**Intel[®] 82371AB PIIX4,
Intel[®] 82371EB PIIX4E,
Intel[®] 82371MB PIIX4M**

Specification Update

January 2002

Document Number: **297738-017**

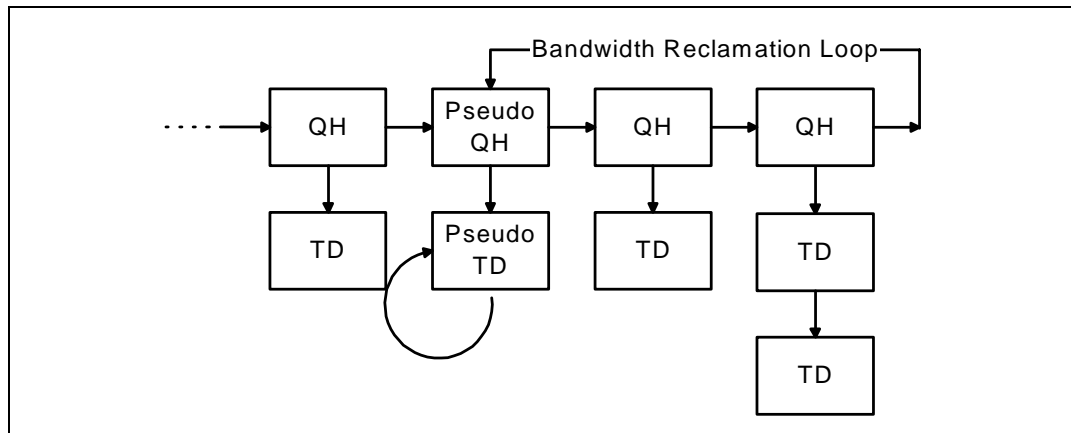
The Active status bit (bit 23) must be left unset at 0 indicating that the PIIX4/PIIX4E/PIIX4M should not execute this TD.

The Queue Head Link Pointer (QHLP=bits [31:4]) must be set to point to the pseudo TD.
